**SECTION 00 91 01
ADDENDUM NUMBER 1**

**PROJECT: ORCHARD VALLEY CLUBHOUSE HVAC RENOVATIONS
2411 W ILLINOIS AVENUE
AURORA, ILLINOIS 60506**

PROJECT NO: 17-253-1110

M300

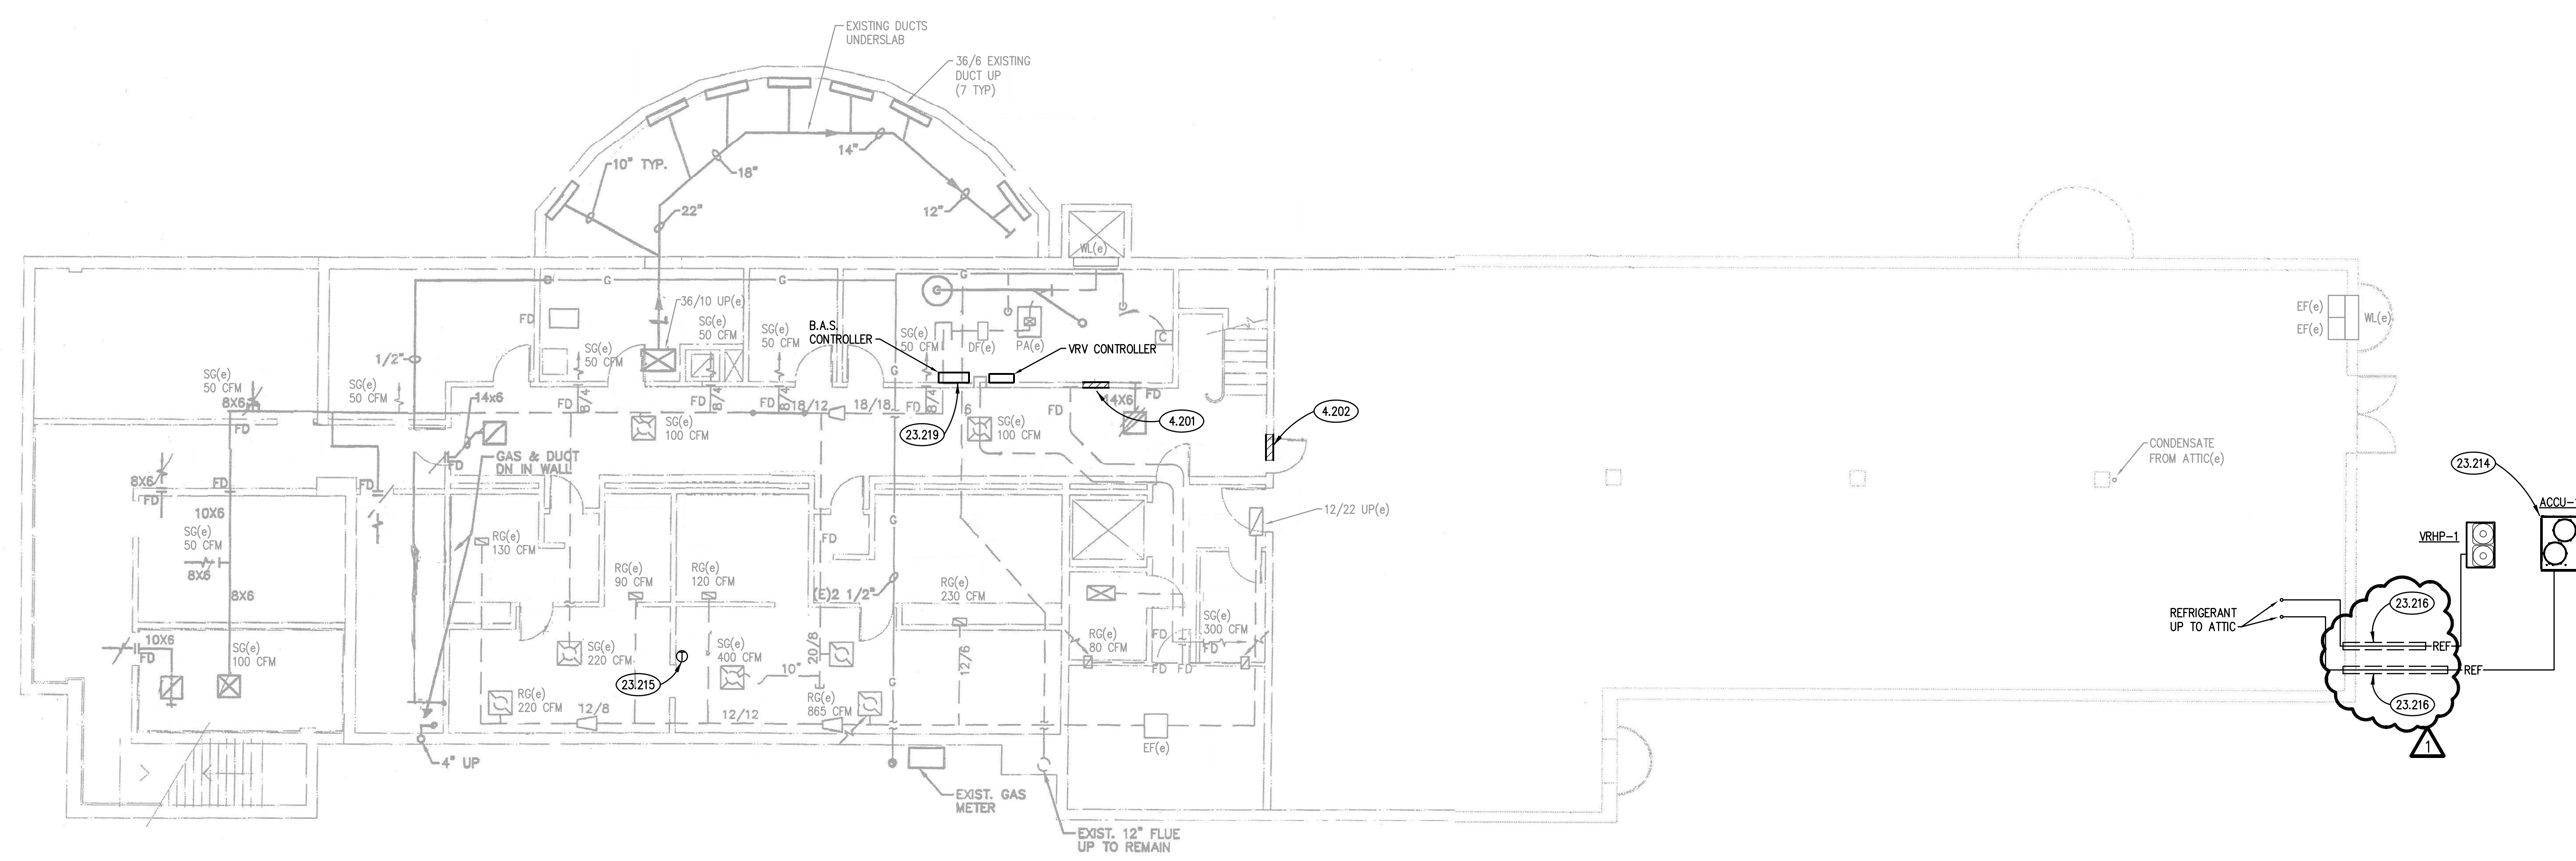
- A. Delete this Drawing in its entirety and replace with revised Drawing M300 - MECHANICAL FLOOR PLANS (attached).
